CITY OF PORTLAND

BUILDING PERMIT

Job ID: 2011-10-2475-ALTR

has permission to Rebuild Second Level/ add Third Floor Addition (with Partial Interior Renovations to the Third Floor), provided that the person or persons, firm or corporation accepting this permit shall comply with all of the provisions of the Statutes of Maine and of the Ordinances of the City of Portland regulating the construction, maintenance and use of the buildings and structures, and of the application on file in the department.

Spiral
Stair
Detail

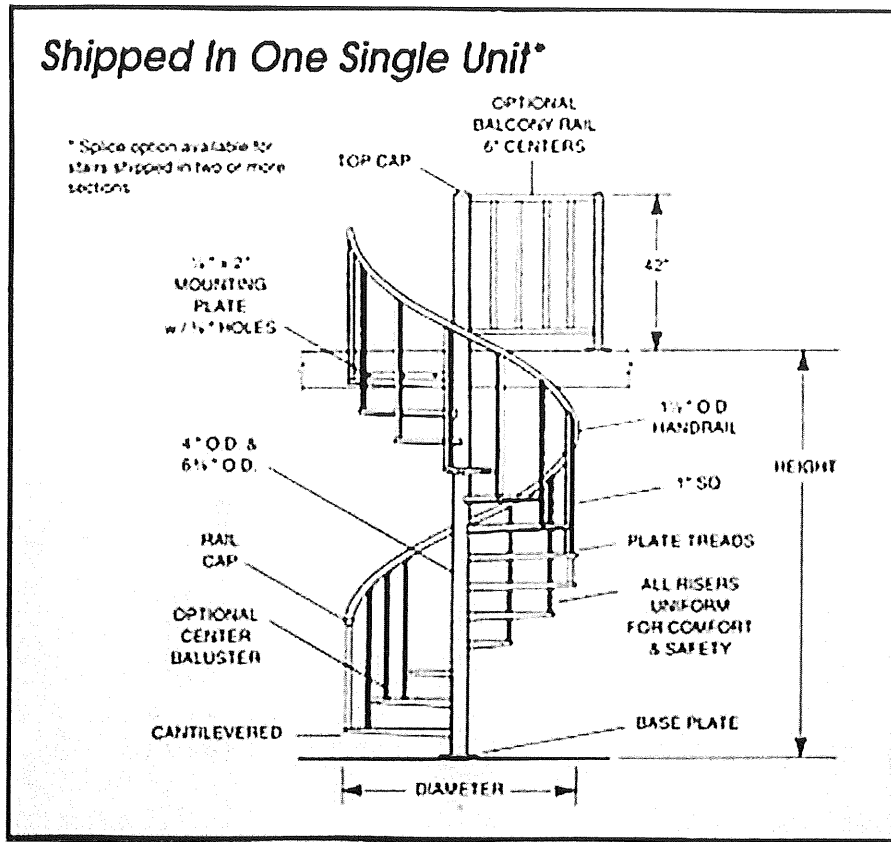
I received your stair detail; the handrail must comply with MUBEC. Attached is the commentary section. JGR.

47-49 Lafayette Plot plan (addendum)

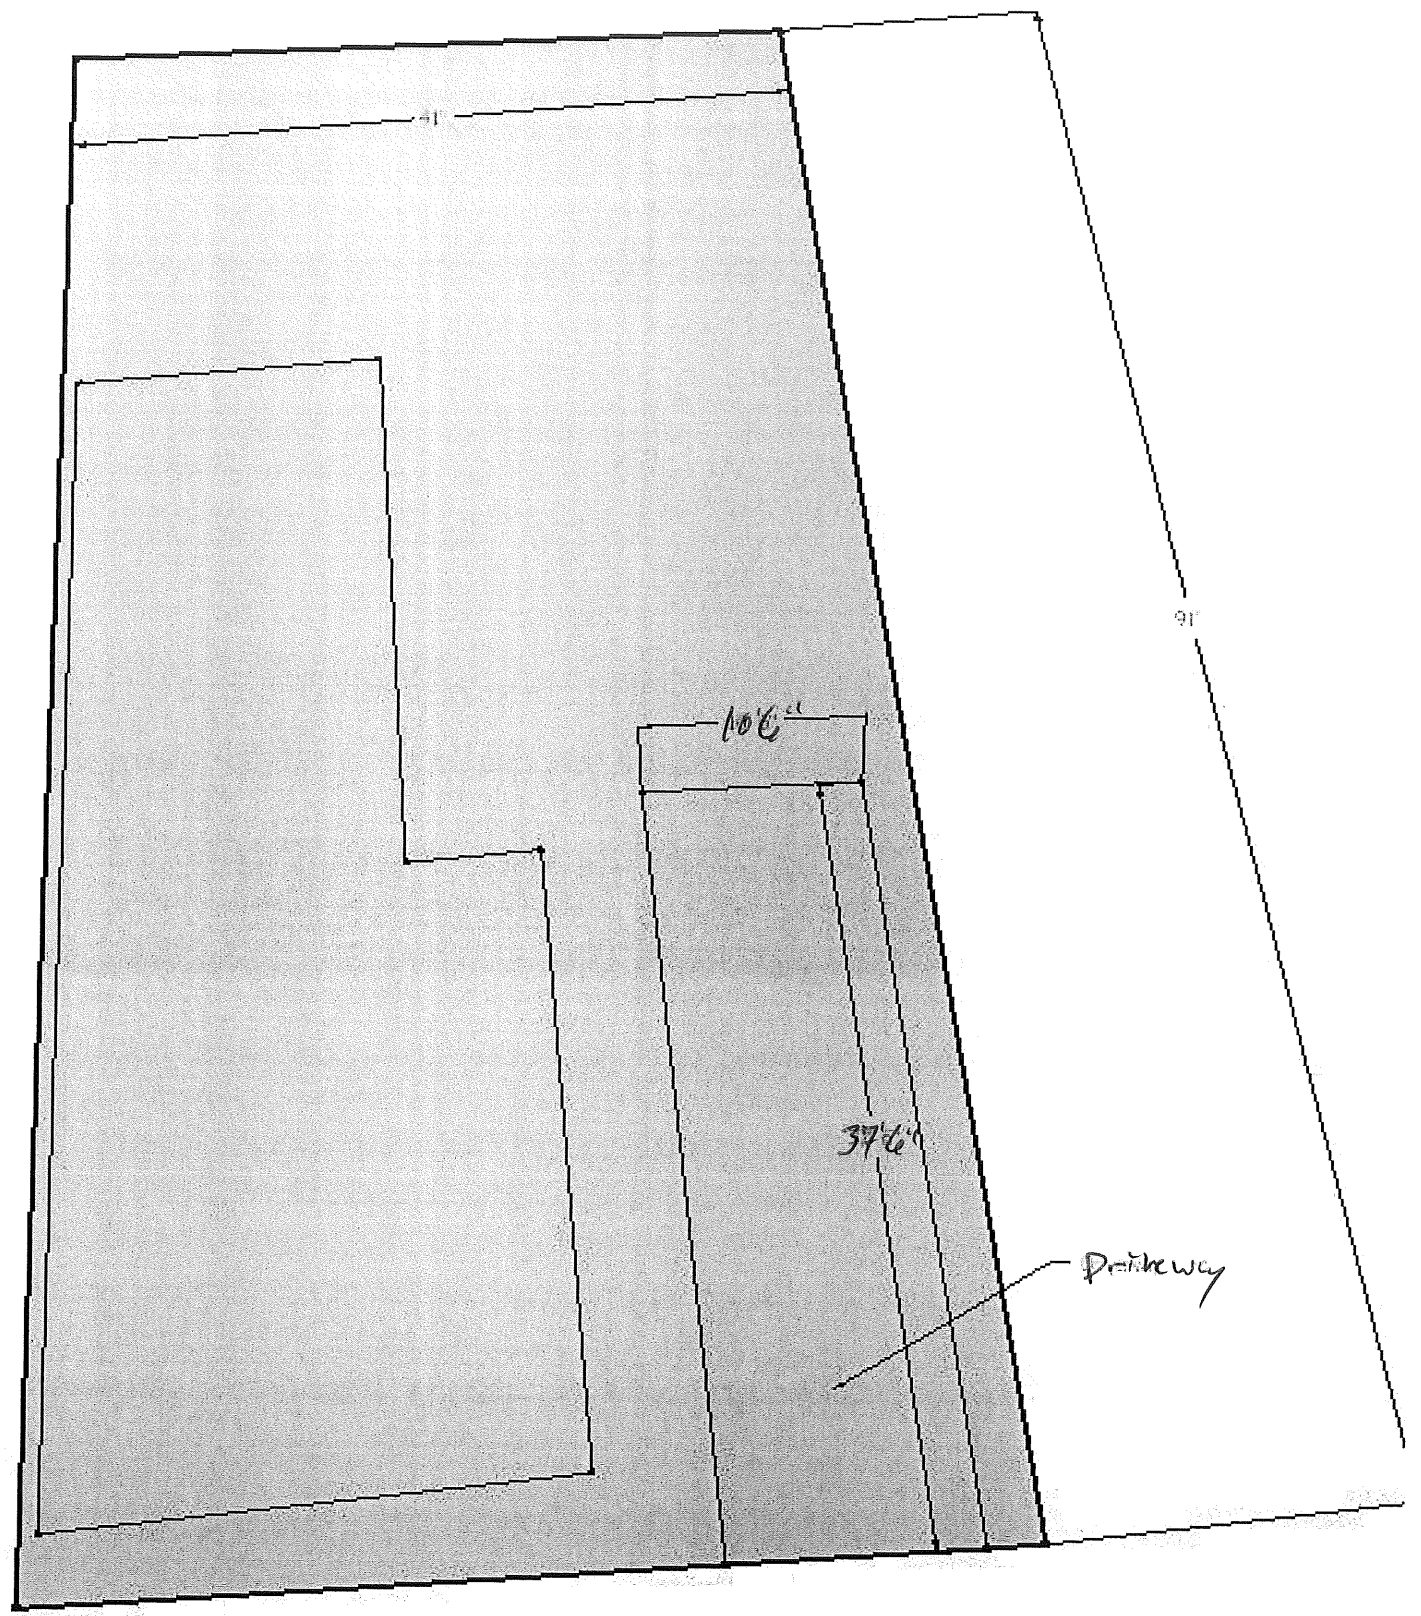
Can you review section R302, see attachment? I took a look at your plot plan, the addition section is > 3 feet.

This would affect window openings and provide protection to the underside of the exterior sheathing.

How far is the adjacent properties? JAR.

Which addition? We only went up. There is no part of the building that is being expanded beyond the original foot-print.

The closest inhabited building is the building to the north, which is probably 15+ feet away. There is a garage - which appears to be used for storage off of the northeast corner of the building. But again, we're not expanding anything outwards towards any of these buildings...
